ES_LPC4350/30/20/10 Rev A

Errata sheet LPC4350, LPC4330, LPC4320, LPC4310 Rev A

Rev. 1.2 — 1 February 2012

3.7 USB0.1: USB0 and USB1 VBUS lines are not 5 V tolerant if part is unpowered

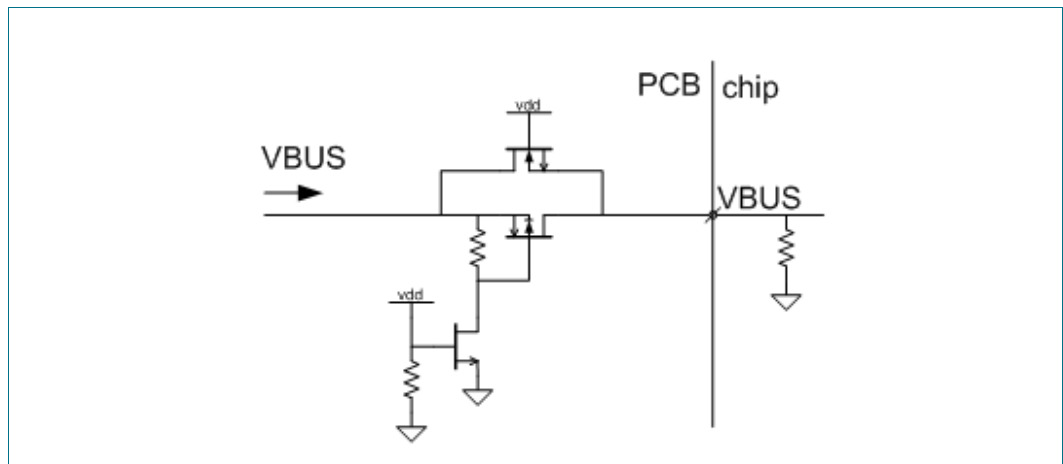
If USB0 or USB1 is used to implement a USB-powered USB device or OTG product, 5 V would be applied to the VBUS line on the LPC43x0 before the LPC43x0 was powered up. However, the VBUS line on the LPC43x0 5 V tolerant only when VDDIO is present.

For a simple USB device-only product, an external voltage divider is enough to prevent excess voltage from appearing on the VBUS line when USB is connected to an unpowered board. A schematic of a recommended voltage divider is shown below.
